Application Drawing for Replacement of Obsolete
LCPN, LCIC, LCPC Controllers (See Note 5)
LAPN-USPR Kit

JTL SYSTEMS LTD	
		41 KINGFISHER COURT, HAMBRIDGE RD, NEWBURY BERKSHIRE: RG14 5SJ TEL: 01635 263646 FAX: 01635 263647	
ISS	DESCRIPTION	APP'D	DATE
1	ORIGINAL ISSUE	MJK	04/07
TITLE: APPLICATION DRAWING FOR REPLACING LC CONTROLLERS WITH LAPN-USPR KIT			
TYPE: LAPN			
PROJ.	DRG No:	SHT	OF
LA	03333	1	1
		ISS.	
		1

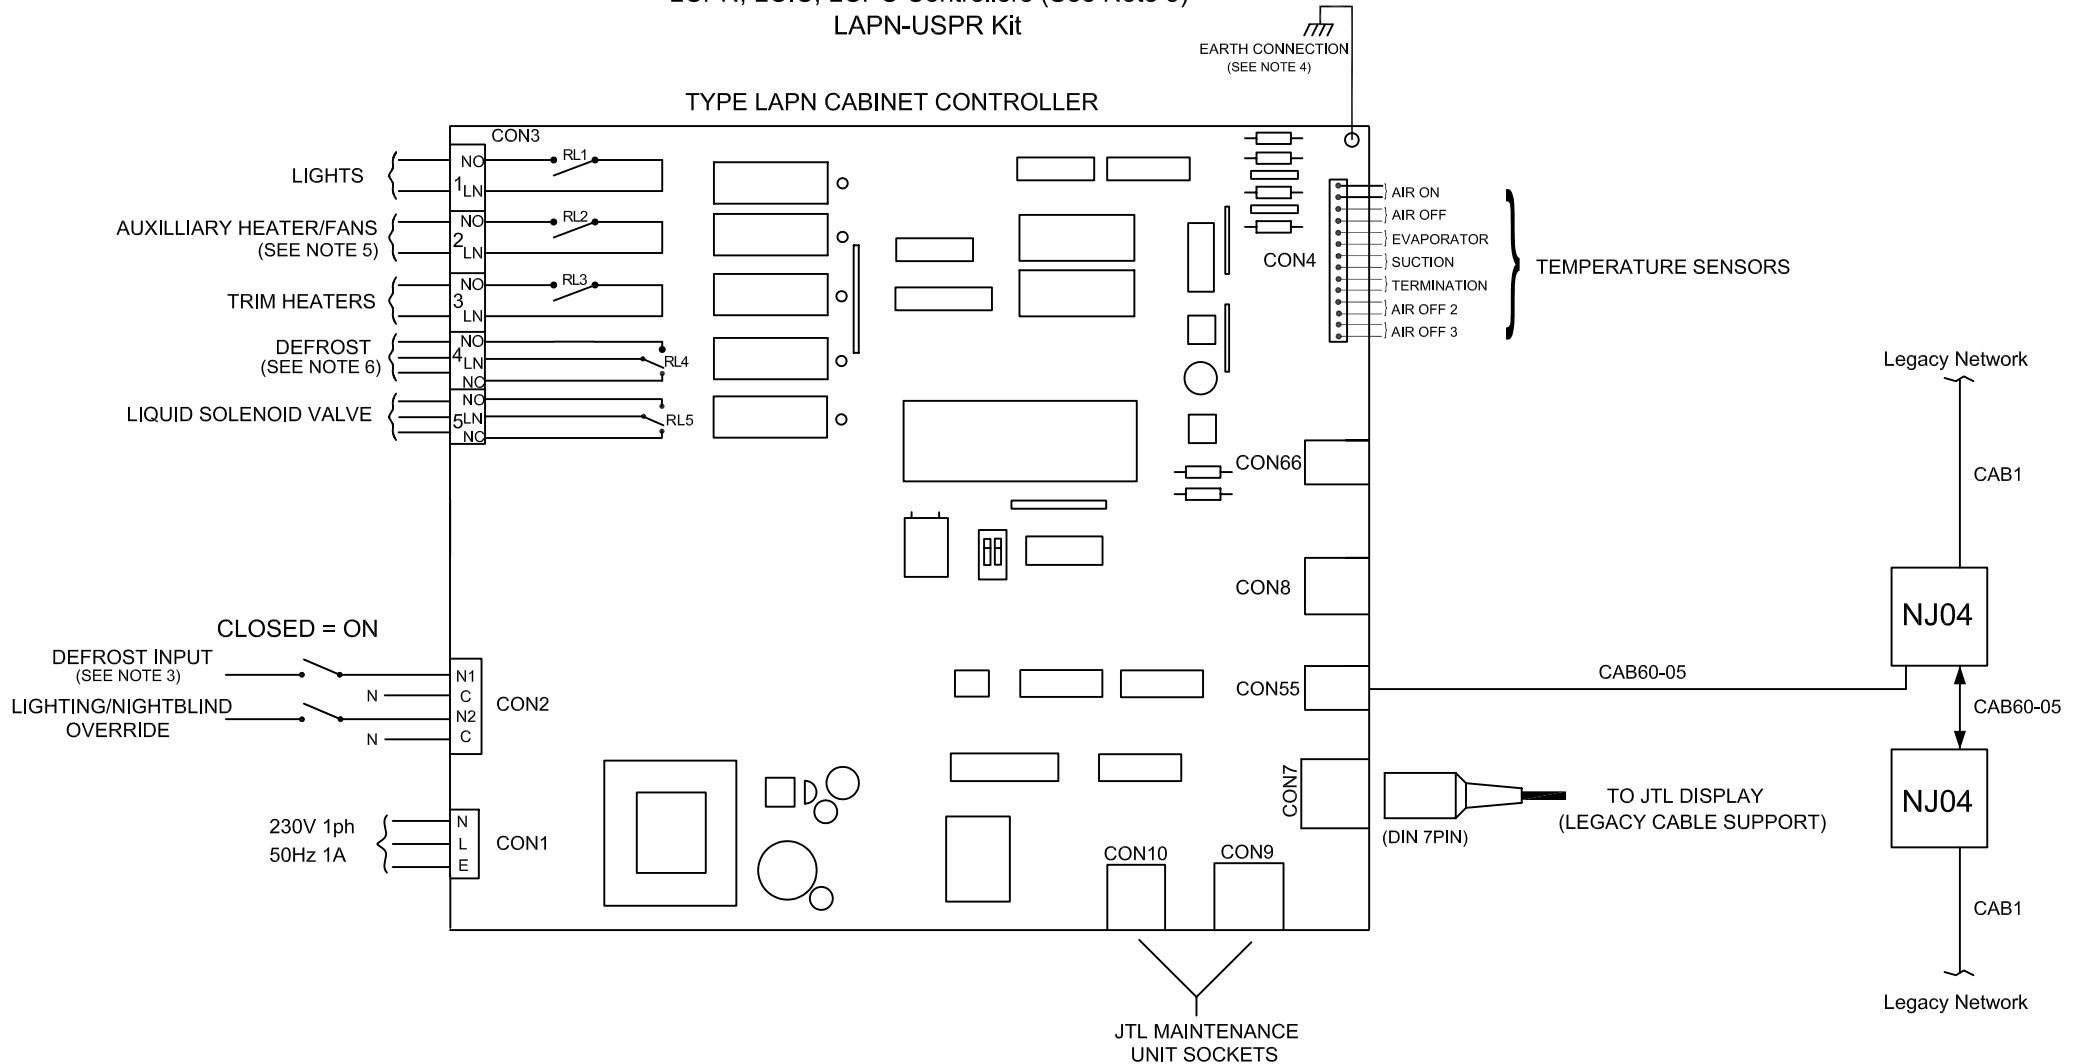
1. CAB66-05 DISPLAY ADAPTER CABLE ALLOWS CONNECTION TO EXISTING 5PIN DIN DISPLAY CABLE.
2. TEMPERATURE SENSORS ARE CONNECTED DIRECTLY TO SCREW TERMINALS ON BOARD, AND NO LONGER THROUGH A CON4TS BREAKOUT BOARD.
3. WHERE THE INPUT I1 IS USED REWIRING WILL BE REQUIRED. THE INPUT IS DIFFERENT TO THE ECxx RANGE. TO ACTIVATE THE INPUT LINE VOLTAGE (230Vac) IS REQUIRED WITH A NEUTRAL OR THE COMMON (C).
4. ALL INPUT, RELAY CONNECTIONS AND SUPPLY MUST BE ON THE SAME PHASE. THE METAL ENCLOSURE MUST BE EARTHED.
5. LAPN -USPR FROM FIRMWARE VERSION 0.00.6 CAN REPLACE ALL LCPN CONTROLLERS AND MOST LCIC & LCPC CONTROLLERS WHEN OPERATING MECHANICAL EXPANSION VALVES.
